# CITY OF ALBUQUERQUE

**RE: Cohen Project**  
**2929 Candelaria Rd. NE**  
**Grading and Drainage Plan Stamp Date: 5/21/21**  
**Hydrology File: G16D111A**

Based on the submittal received on 6/23/21, the Grading and Drainage Plan is approved for Building Permit by Hydrology.

## GRADING & DRAINAGE PLAN

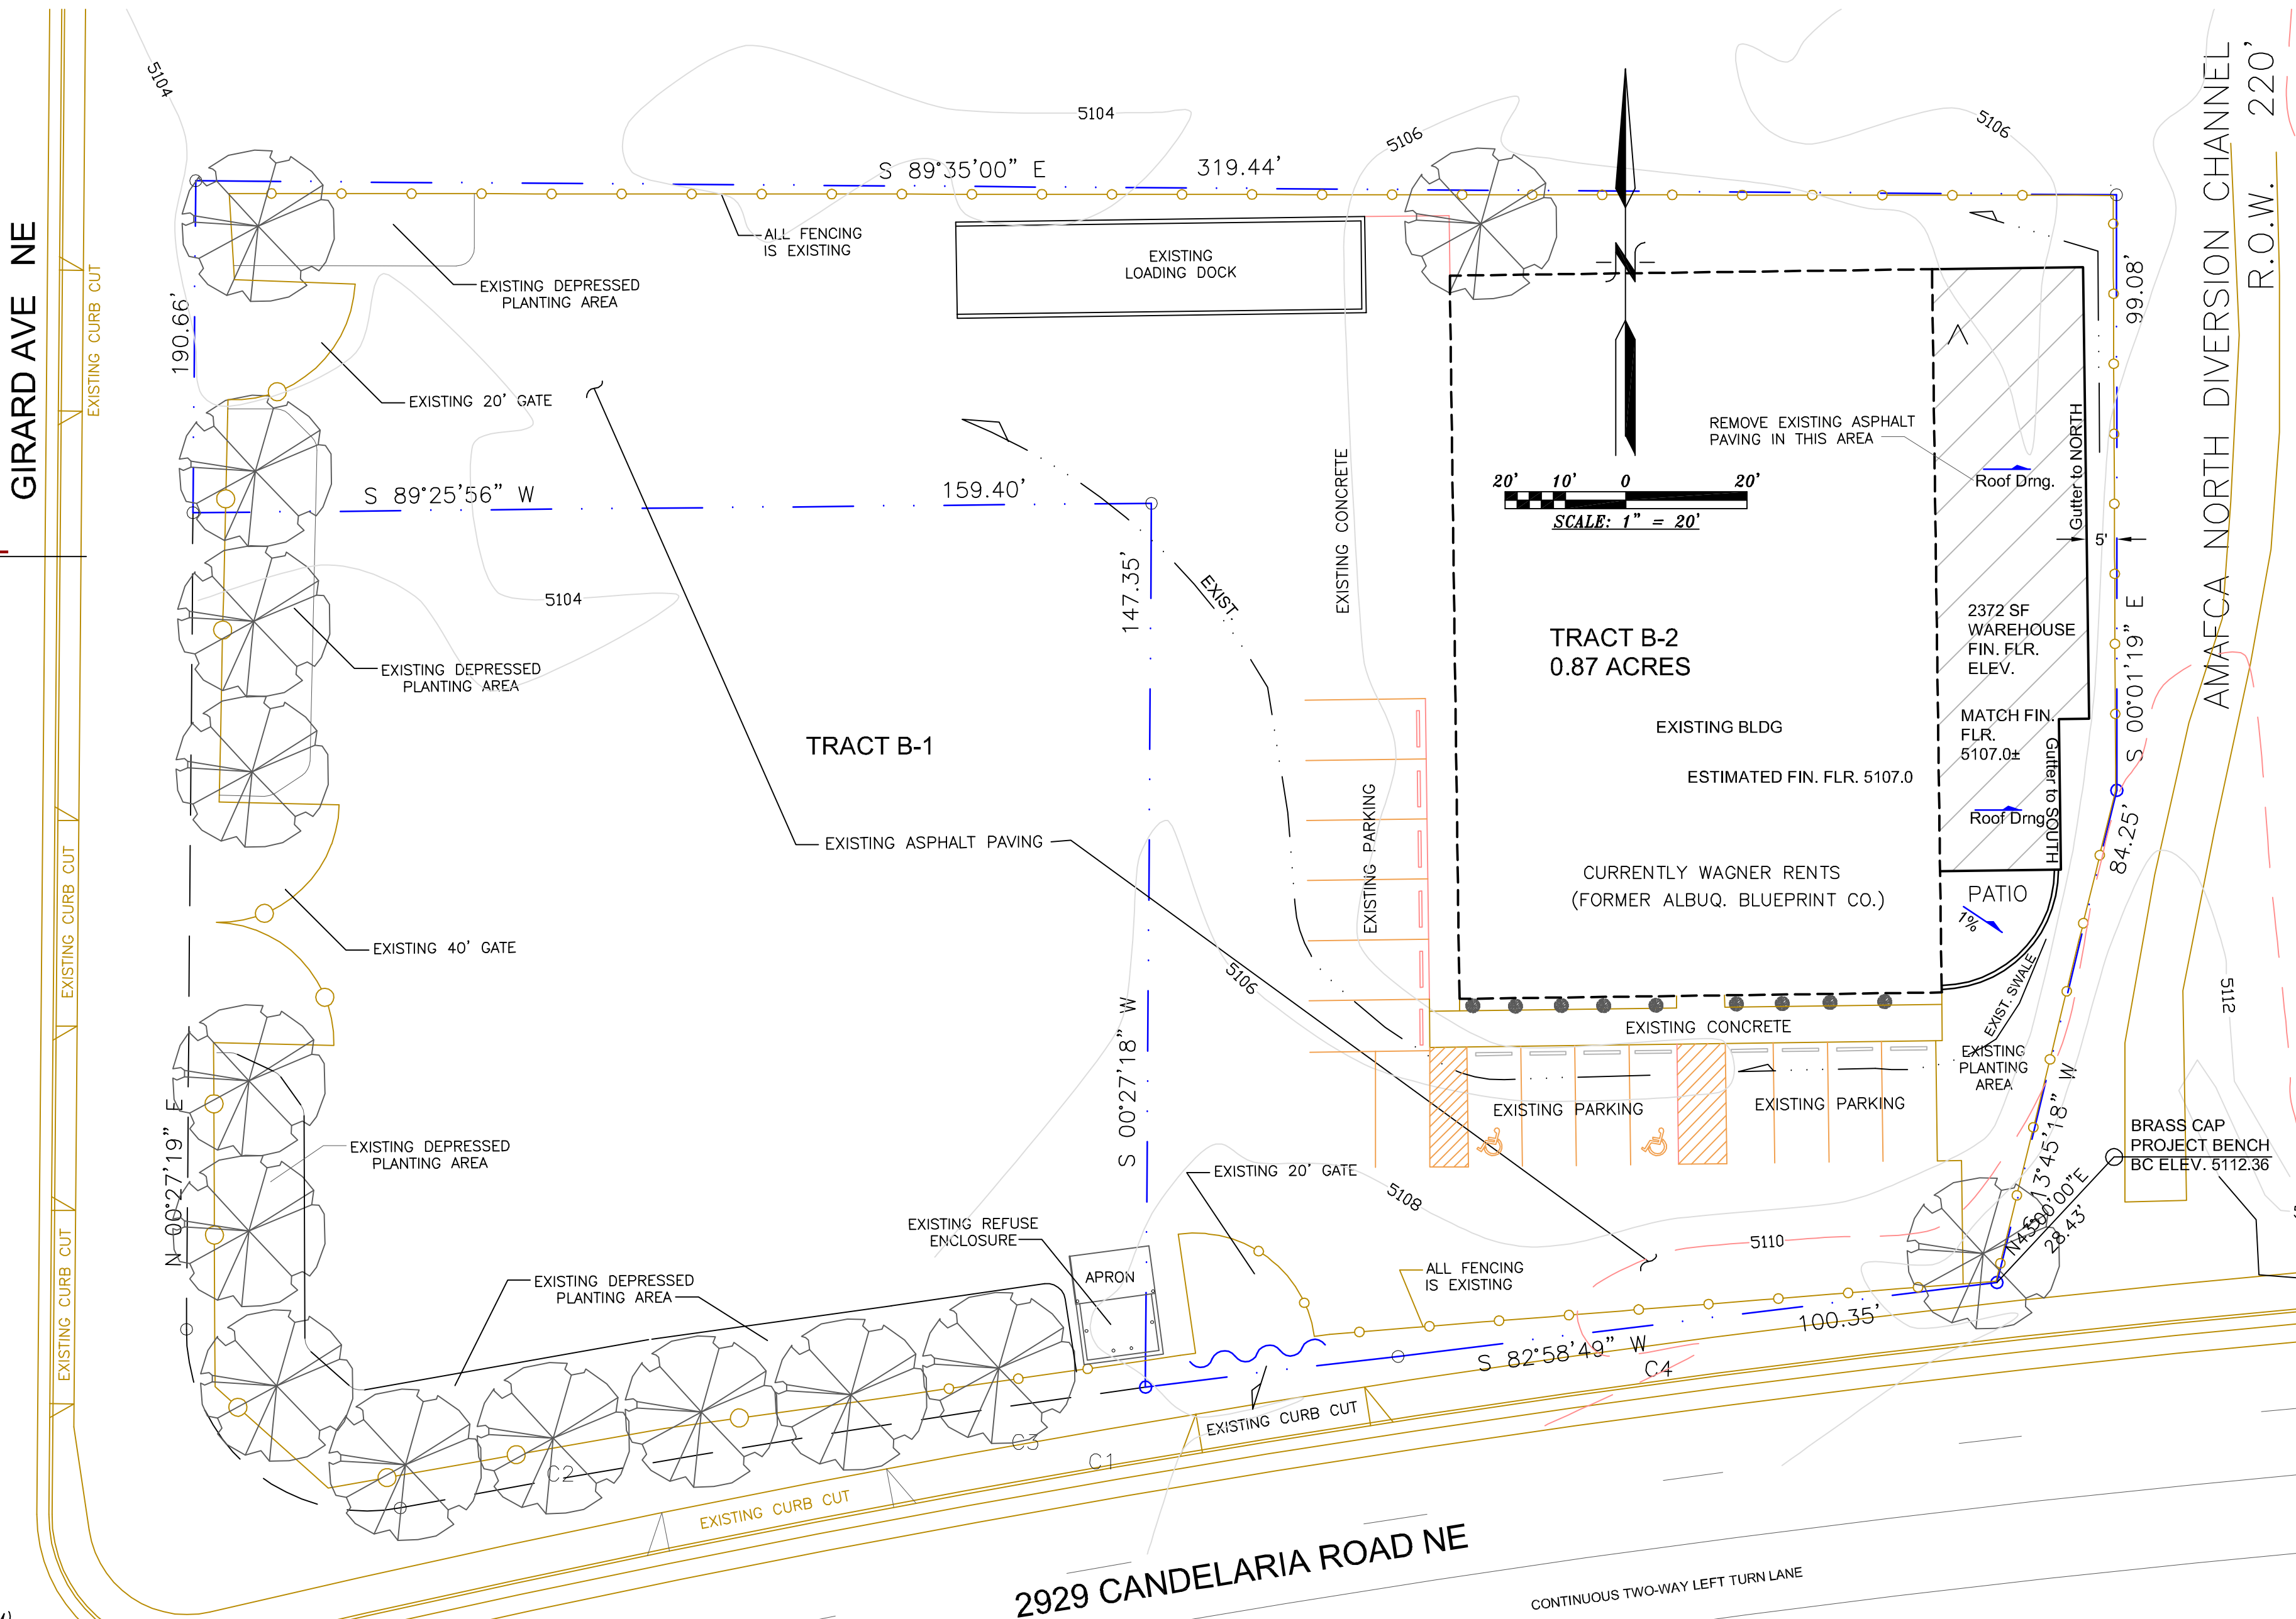
As a reminder, if the project total area of disturbance (including the staging area and any work within the adjacent Right-of-Way) is 1 acre or more, then an Erosion and Sediment Control (ESC) Plan and Owner's certified Notice of Intent (NOI) is required to be submitted to the Stormwater Quality Engineer (Doug Hughes, PE, [jhughes@cabq.gov](mailto:jhughes@cabq.gov), 924-3420) 14 days prior to any earth disturbance.
